LISTED BUILDING GROUND FLOOR DEMOLITION PLAN - APPROVED

LISTED BUILDING GROUND FLOOR DEMOLITION PLAN - NMA SUBMITTED

LISTED BUILDING GROUND FLOOR DEMOLITION PLAN - NMA AMENDMENT CHANGES

PROJECT	Laystall St
DATE	SEPT' 20
SCALE	1:100
DWG No.	1383 / SK0030

SHOWROOM PROPOSED NORTH ELEVATION - NMA AMENDMENT CHANGES

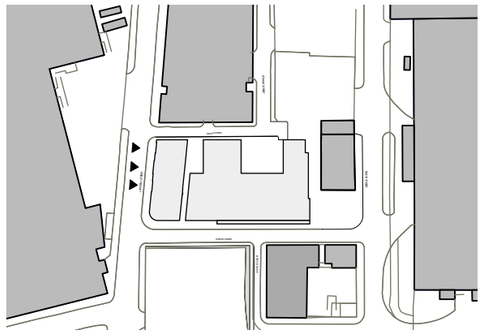
BRICK PIER REDUCED TO 440MM
FROM 665MM

PROPOSED ENTRANCE OMITTED
AND REPLICATED WITH FIXED
GLAZING

SHOWROOM PROPOSED WEST ELEVATION - NMA AMENDMENT CHANGES

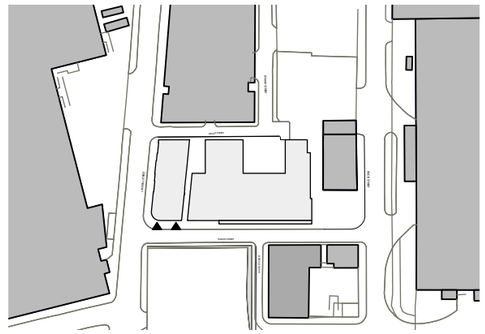
2 WINDOWS AND ASSOCIATED TERRACOTTA ROSES OMITTED TO ALIGN OPENING TO PROPOSED GROUND FLOOR ENTRANCE

BRICK PIER REDUCED TO 440mm FROM 665mm

GROUND FLOOR ENTRANCE INTROCUED ON PIGEON ST. RECESSED BRICKWORK BANDING OMITTED

SOLDIER COURSED BAND OF BRICKWORK EXTENDED TO SIT OVER DOORWAY

SHOWROOM PROPOSED SOUTH ELEVATION - NMA AMENDMENT CHANGES

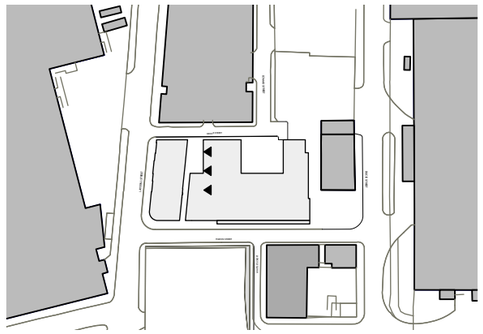
OPENINGS IN REAR ELEVATION UPDATED
FOLLOWING DEMOLITION OF OUTRIGGER

LIGHTING POSITIONS ADDED TO DRAWINGS

MVHR VENTILATION DUCTS TO BE
OMITTED
